ROCKY FLATS SITE
REGULATORY CONTACT RECORD

Purpose: Rocky Flats Legacy Management Agreement Attachment 2: Modification to Revise Monitoring Points

Contact Record Approval Date: July 15, 2010

Figure 1. Monitoring and Dam Breach Locations—Woman Creek Drainage Area

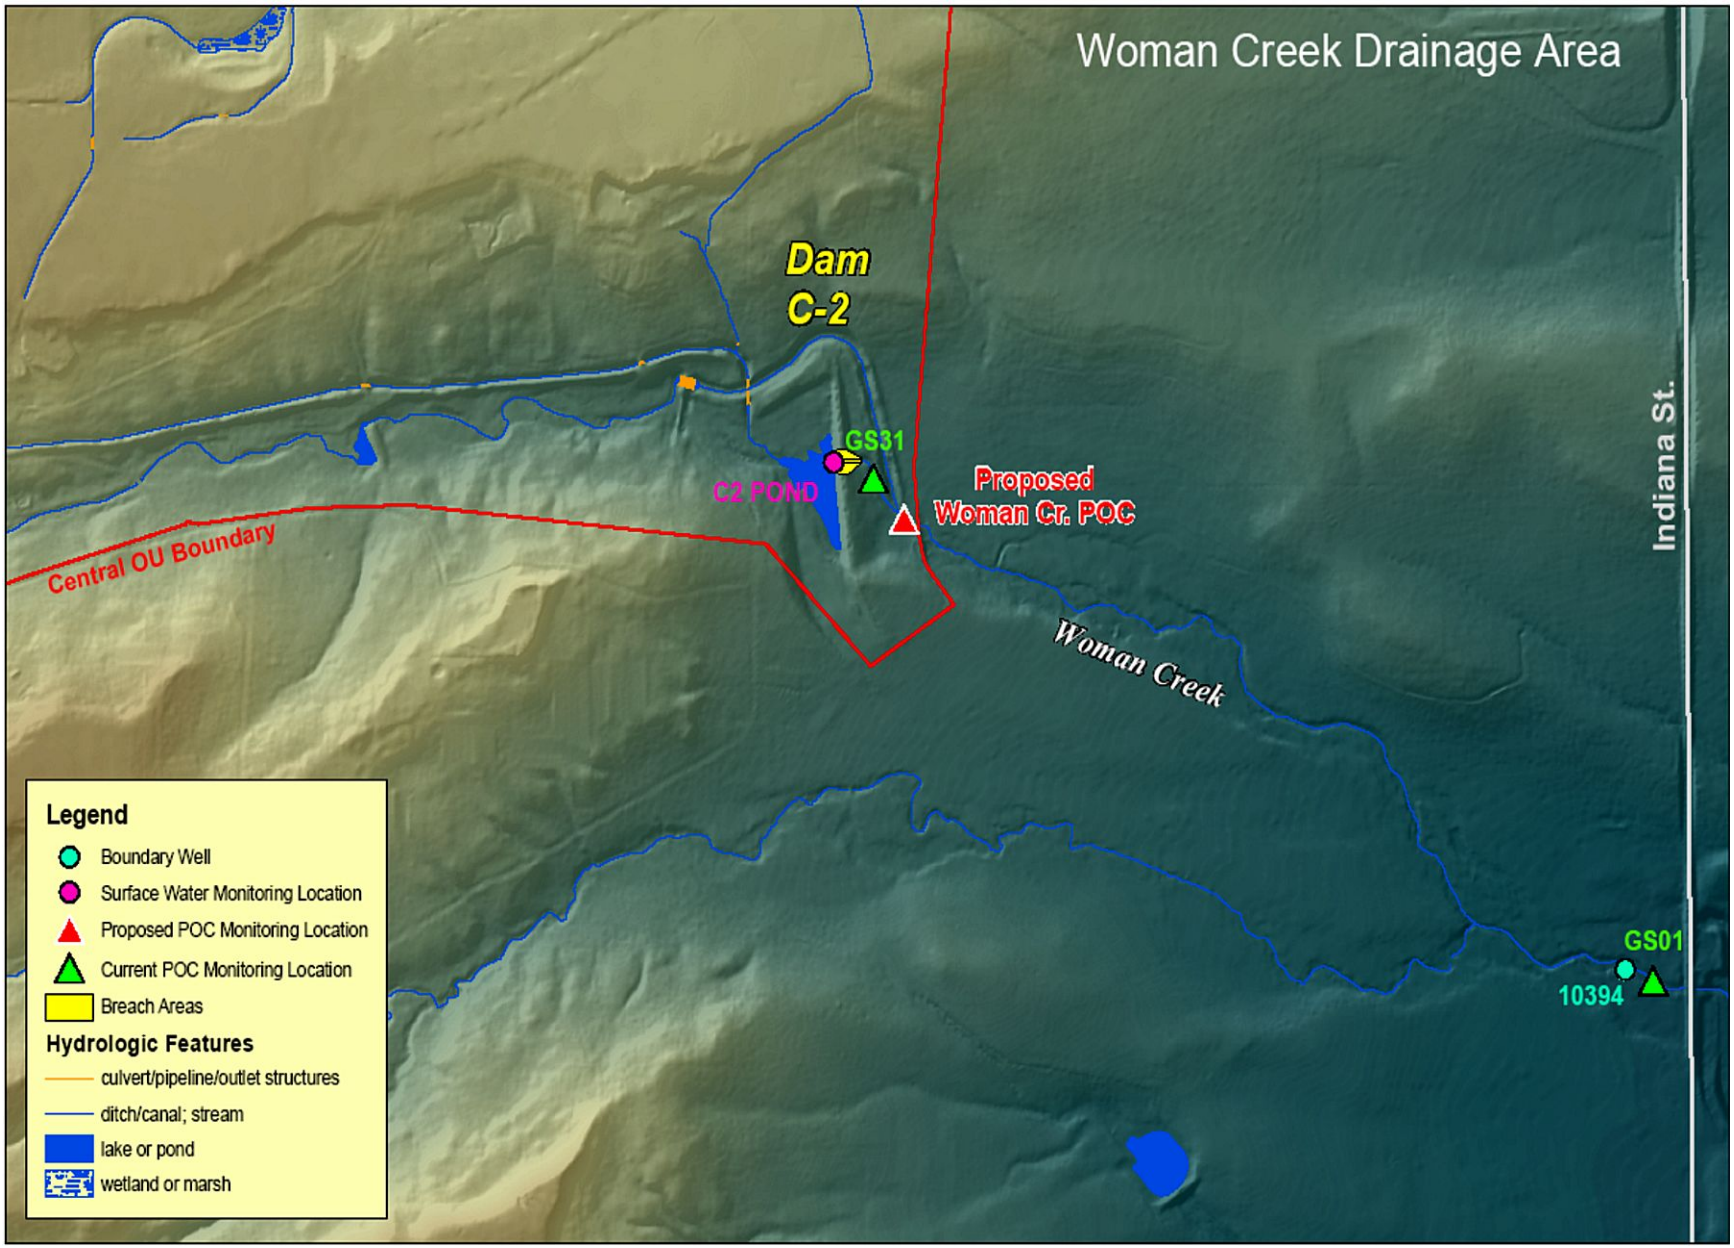
Figures 1 and 2 in this Contact Record also show the current required monitoring locations, the monitoring locations that DOE proposes to eliminate, and DOE's proposed new monitoring locations. The relevant monitoring locations are listed in Table 1 as well. Figures 1 and 2 also show the locations of the remaining ponds and dams and the approximate footprints of the construction areas for the proposed dam breach based on the preliminary design used in preparing the EA.

GS31	Surface water POC—At outfall of Pond C-2 upstream of Woman Creek	Yes	Yes	Replace with new POC in Woman Creek near COU boundary. Compliance value remains based on 12-month rolling average, but DOE will use 30-day rolling average to trigger consultation with CDPHE on whether mitigating actions are required.
PLFPONDEFF	Surface water grab sample location to determine water quality downstream of Present Landfill Treatment System if treatment system effluent exceeds RFLMA standards	No	Yes	A new sampling point ID will be assigned. Grab sample location will be in No Name Gulch near the proposed PLF dam notch after notching. This is the approximate downstream location of the current PLFPONDEFF location.
Pond A-4	Operational monitoring surface water grab sample location for pre-discharge sampling	No	Yes	Remove—operational monitoring not needed; pre-discharge sampling no longer relevant once surface water flow-through condition is restored.

Pond B-5	Operational monitoring surface water grab sample location for pre-discharge sampling	No	Yes	Remove—operational monitoring not needed; pre-discharge sampling no longer relevant once surface water flow-through condition is restored.
Pond C-2	Operational monitoring surface water grab sample location for pre-discharge sampling	No	Yes	Remove—operational monitoring not needed; pre-discharge sampling no longer relevant once surface water flow-through condition is restored.

Figure 2. Monitoring and Dam Breach Location—Walnut Creek Drainage Area

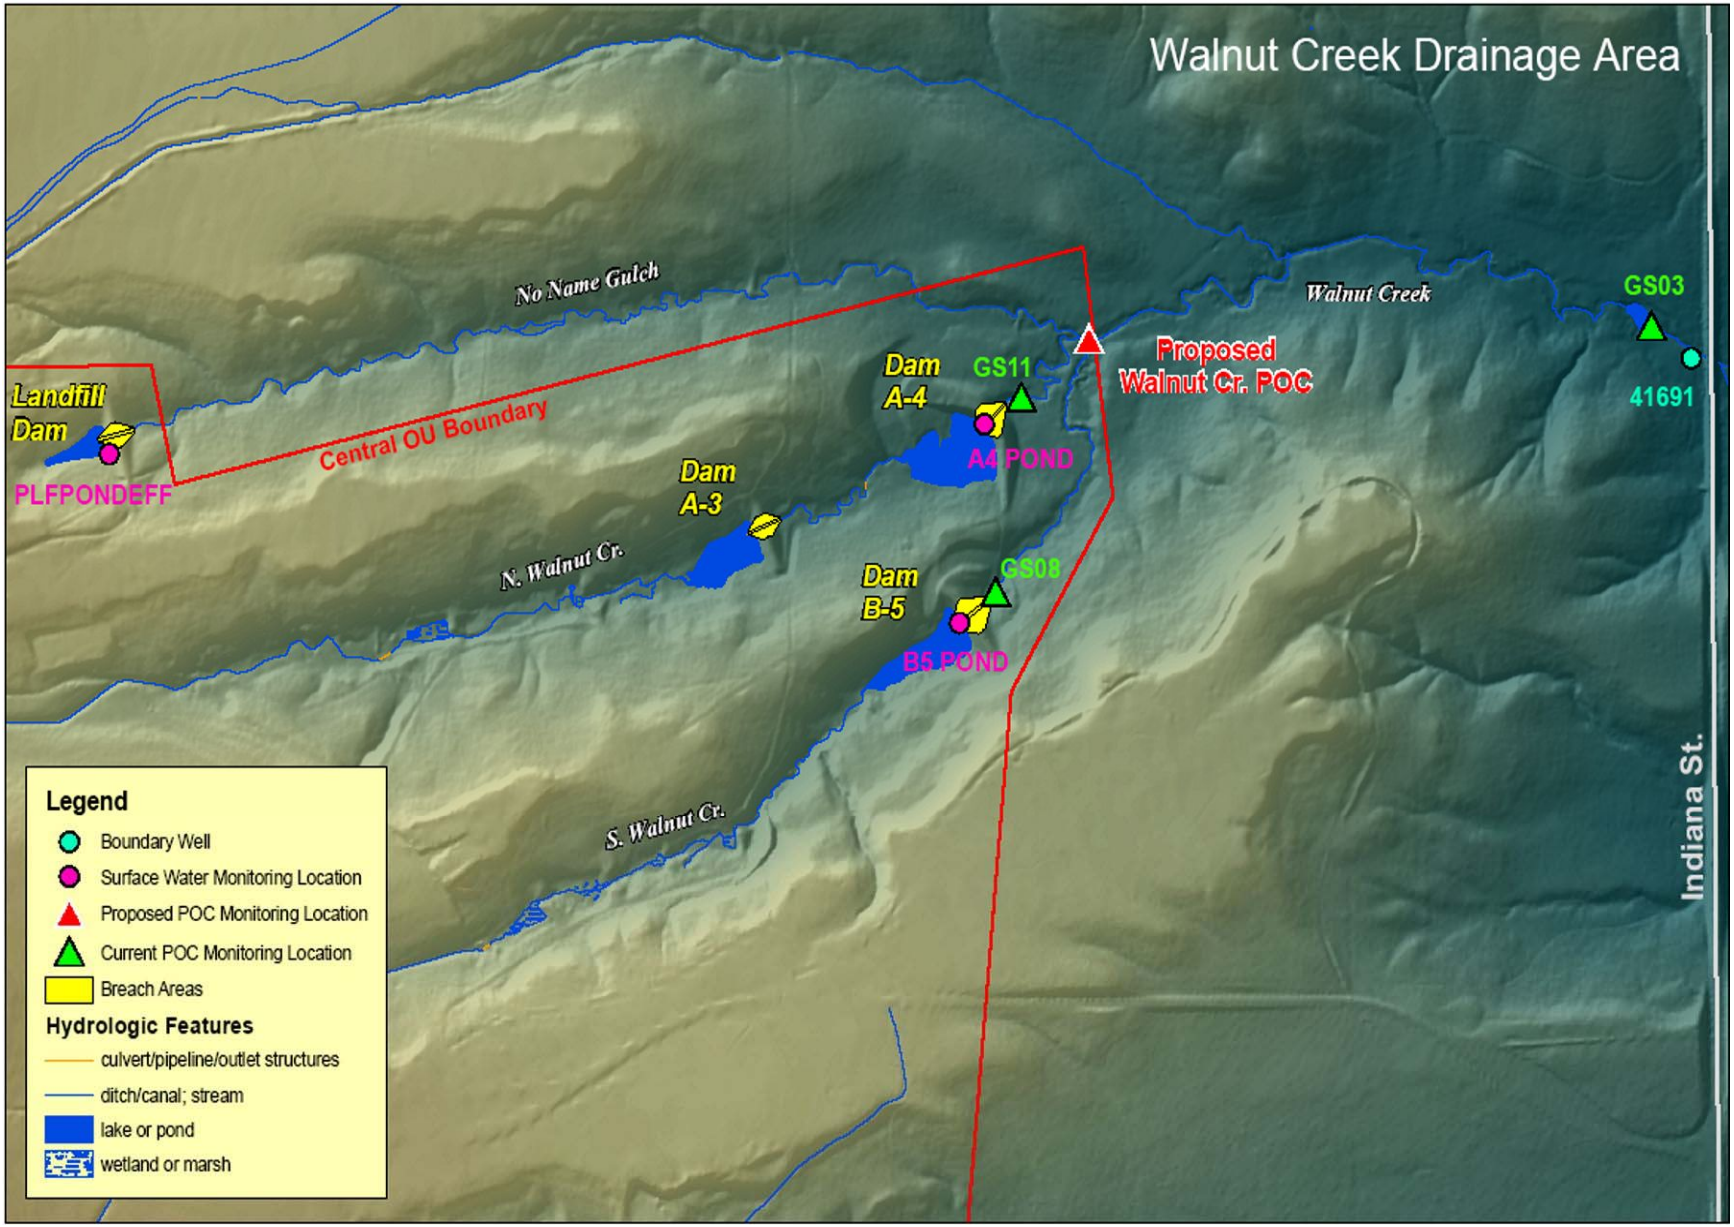
- The Colorado Water Quality Control Commission moved the eastern end of Big Dry Creek Segment 5 (which includes Walnut Creek) to the eastern Central Operable Unit boundary as part of the 2009 triennial review of the Classifications and Numeric Standards for South Platte River Basin—Regulation 38 (5 CCR 1002-38), and the proposed Walnut Creek monitoring location will remain in Segment 5.
